SAFETY RECALL ACTION

Reference number:	RA-01-1327	Issued: 21 November, 2019
Subject:	Incorrect Installation of the Passenger Airbag	
Model(s):	DB11, Vantage (19MY), DBS Superleggera	
VIN Range:	Refer to the separately published list of Vehicle Identification Numbers (VINs)	
Applicable to:	All Dealers	
Distribute to:	After Sales Manager Executive Manager Service Manager Sales Manager	Warranty Staff Technician(s) Parts Staff

Safety Recall Action RA-01-1327 – Incorrect Installation of the Passenger Airbag

Figure 5

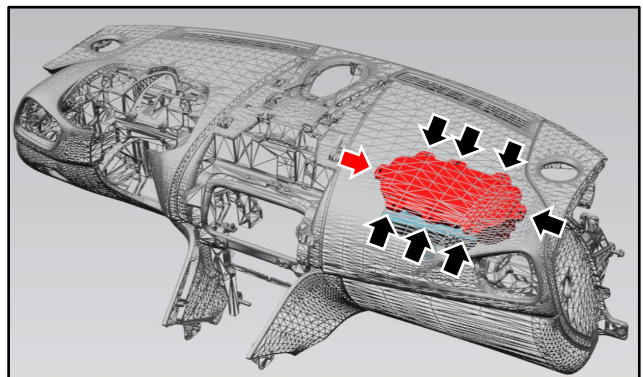
4. Use a fibre-optic camera to inspect the seven locking nuts that are accessible in the locations shown (refer to Figure 5).

Note: There are eight locking nuts in total, but one locking nut is not visible (refer to the red arrow).

Figure 6

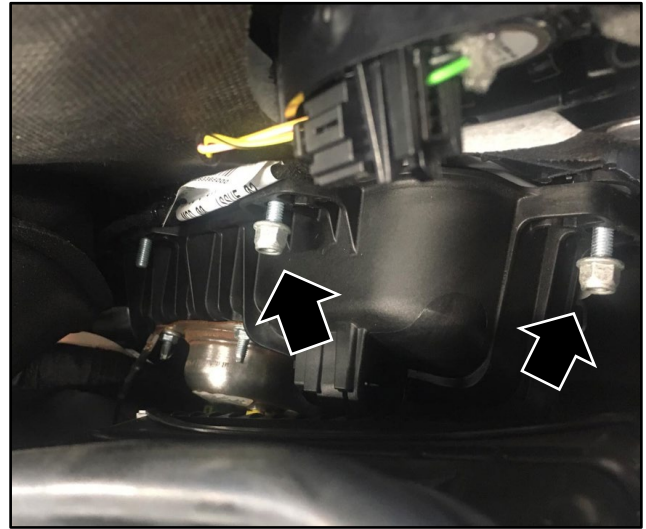
5. If any of the locking nuts are not installed correctly (refer to Figure 6) go to Part B: Torque the Locking Nuts to the Correct Specification.

2. Torque the eight locking nuts that attach the passenger airbag to the IP to 6.5 Nm.
3. Install the front evaporator and heater assembly (refer to Workshop Manual procedure 12.03.AH).
